H11497

## DESCRIPTIVE REPORT

### Descriptive Report to Accompany Hydrographic Survey H11497

Project OPR-P158-FA  
 Approaches to Cordova, Alaska  
 Scale 1:10,000  
 August - September 2005  
**NOAA Ship FAIRWEATHER**  
 Chief of Party: Captain John E. Lowell, Jr., NOAA

**Figure 3: Shadow zone and least depth of a submerged rock NE of North Island**

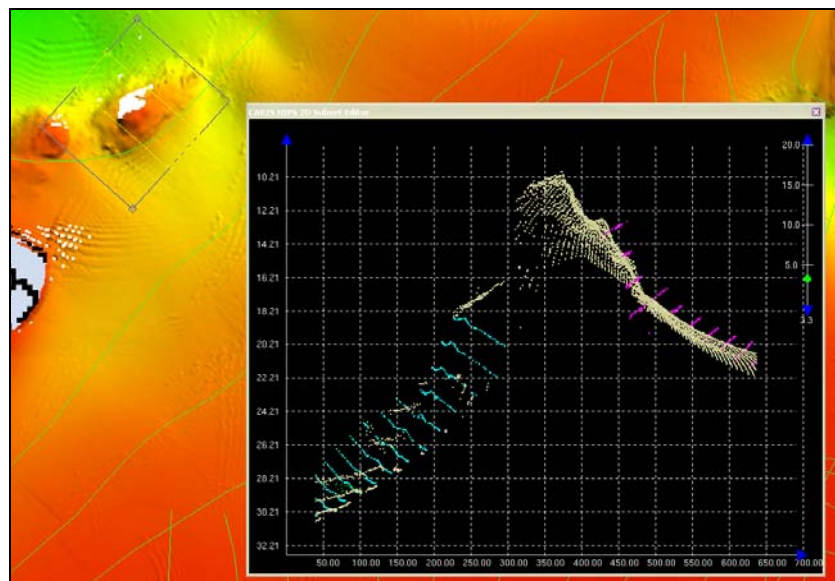
Off the shore of North I, at position 60°37'38.04N, 145°43'14.03W, there is a 10 x 20m holiday in the shadow zone of a submerged rock. The holiday was examined in CARIS Subset editor (see Figure 3), and the Hydrographer is confident a least depth of 10.0m from the feature was obtained<sup>6</sup>.

<sup>6</sup> Chart rock at 60-37-38.04, 145-43-14.03.

**Figure 4: Two holidays offshore of Knot Pt – one with and one without a measured least depth.**

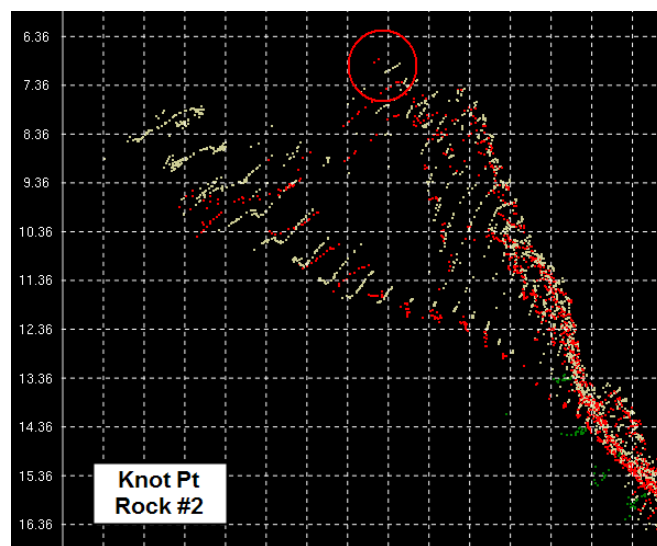
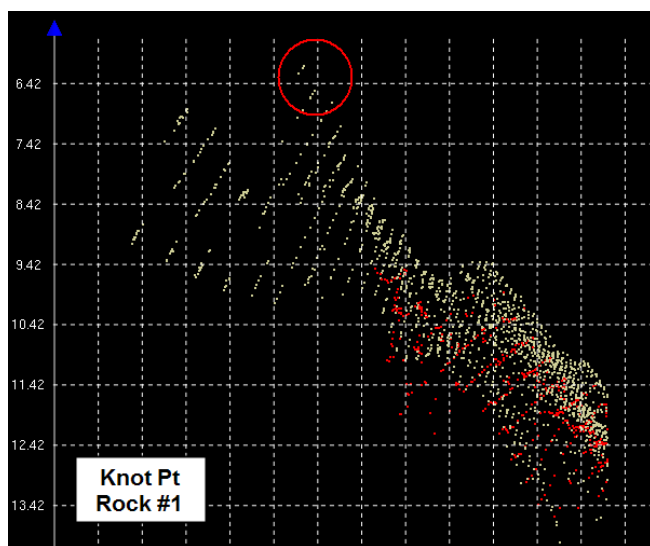
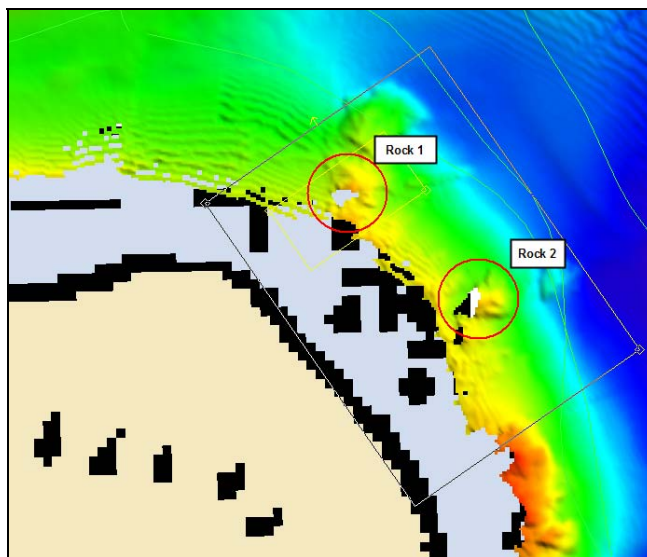
There are three charted rocks offshore of Knot Point, two of which did not get 100% MBES coverage (see Figure 4). For the northern rock, Rock 1, ( $60^{\circ}35'35.8''\text{N}$ ,  $145^{\circ}45'46.8''\text{W}$ ) a depth of 6.2m was measured, though this is not necessarily the least depth of the rock. Shallow conditions and the proximity to shore prevented the survey launches from obtaining additional coverage. Unlike Rock 1, Rock 2 ( $60^{\circ}35'34.6''\text{N}$ ,  $145^{\circ}45'44.1''\text{W}$ ) had a successful measured least depth of 6.7m.<sup>7</sup>

<sup>7</sup> The three charted rocks disproved:

60-35-36.0, 145-45-48.6

60-35-35.0, 145-45-45.8

60-35-34.3, 145-45-44.3

Chart islets at:

60-35-35.5, 145-45-48.8

60-35-34.3, 145-45-45.1

**Figure 5: Holiday resulting from poor line spacing between days (0.8m resolution surface shown)**

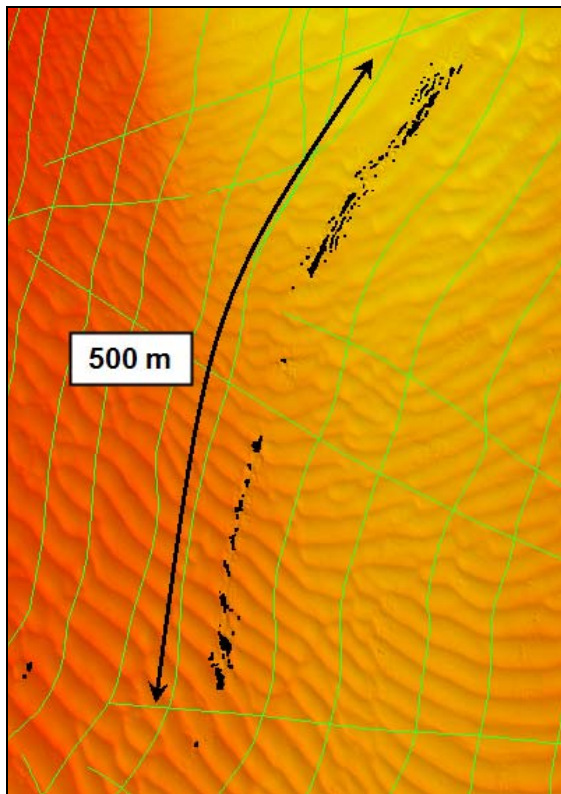
There is a gap in the data collected by Launch 1010 on September 12, 2005 and September 13, 2005 (DN 255 – 256), resulting in a seam of thin coverage in the area of overlap. As shown in Figure 5, the affected area is approximately 500 meters long, with an average width of 3 to 5 meters. A similar holiday developed at position 60°33'58.8"N, 145°45'04.3"W, where the overlap between the two launches was insufficient (see Figure 6). The backscatter imagery of the two affected areas were examined and no contacts were noted.<sup>9</sup>

<sup>9</sup> Small holidays, no evidence of shoaling, excluded from HCell.

Figure 7: Data gaps resulting from transmission breaks in the MBES (0.8m resolution surface shown)

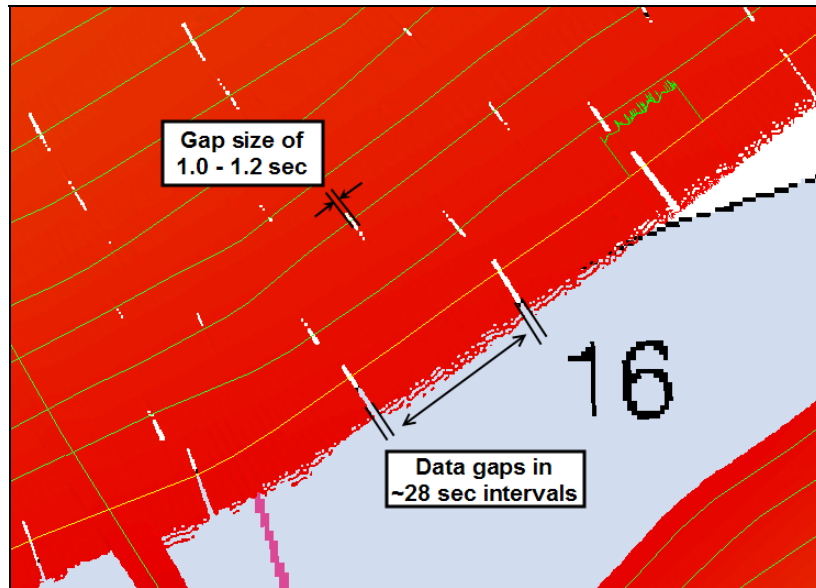
On September 20, 2005 (DN 263) the 8101 on Launch 1018 experienced a strange data transmission error. The MBES would work well for 30 seconds, cease transmitting for approximately one second, then resume operation. These intermittent transmission losses resulted in data gaps with an average size of 2m by 25m in the 0.8m resolution surface shown in Figure 7. Other than the small gaps, the MBES data quality does not appear to be affected.<sup>10</sup>

<sup>10</sup> Small holidays, no evidence of shoaling, excluded from HCell.

**Figure 8: The migration of the southern portion of Western Channel and its associated ATONs (depths shoaler than 18 feet depicted in red)**

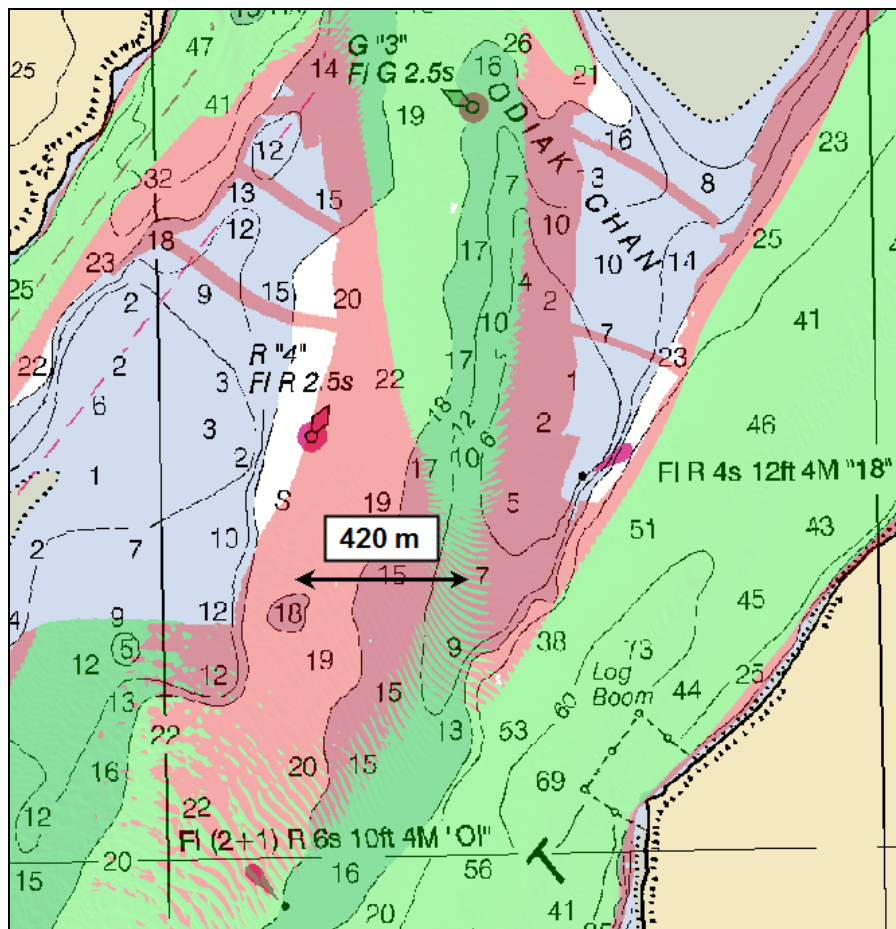
With the movement of Western Channel, Buoy “3”, Buoy “4” and Light “OI” no longer serve their intended purpose. Buoy “3” is presently positioned in the deepest part of the channel and should be moved to the East. Buoy “4” has been overtaken by the shoal and is presently situated in 10 feet of water, making it a poor marker for the western boundary of Western Channel. Finally, Light “OI” is meant to mark the split between Western Channel and Eastern Channel. The southern entrance to Western

Channel has shifted from the western to the eastern side of Light “OI”, making the light obsolete at its present position.<sup>27</sup>

- <sup>27</sup> Concur with clarification. Soundings selected for charting in H11497 reflect the migrated channel. Buoys 3 and 4 no longer mark the channel. Use the latest ATONIS information for charting buoys.

## 1.2) 399/24

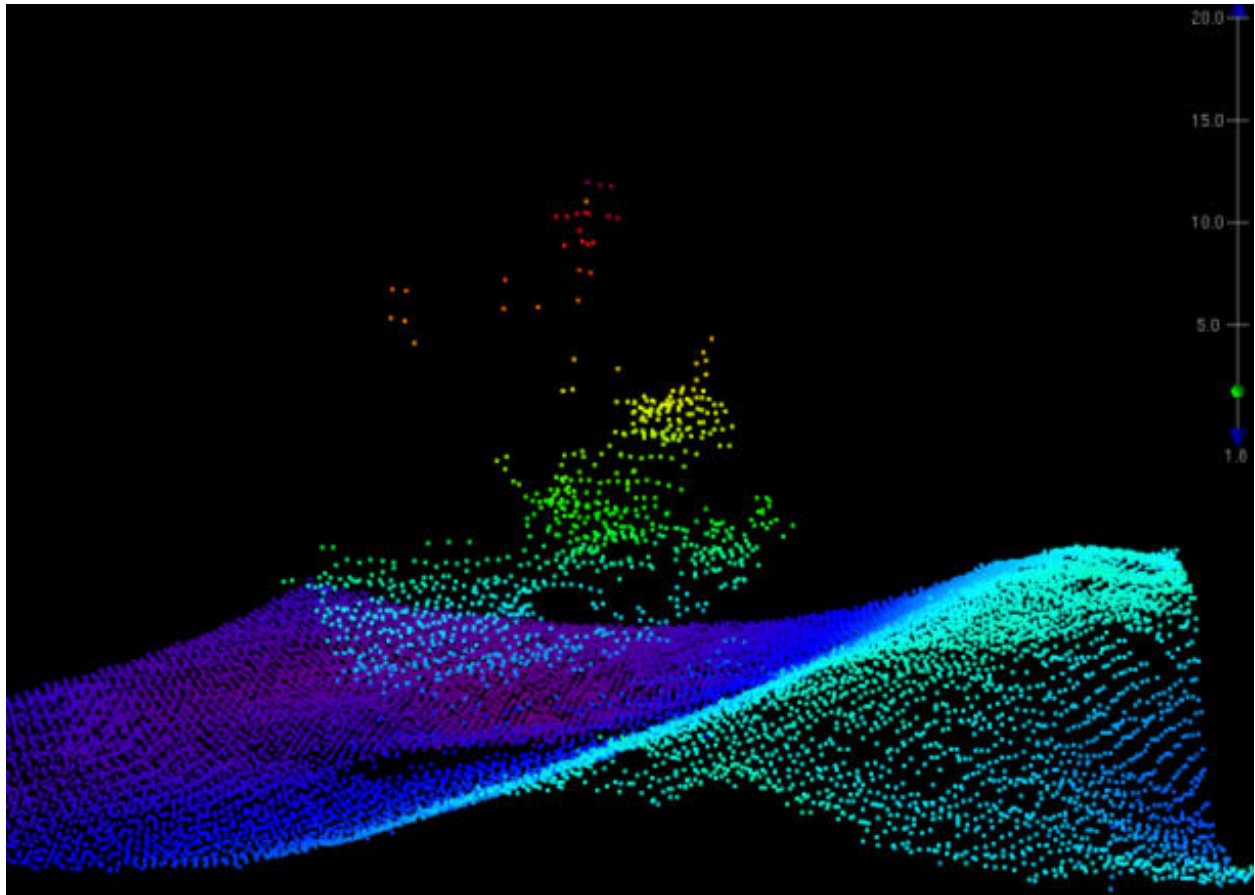
NEW WRECK

New wreck found using MBES (least depth of 4.9 meters).

The Hydrographer recommends adding a wreck symbol to Charts 16710 and 16709.

Compile charted wreck.
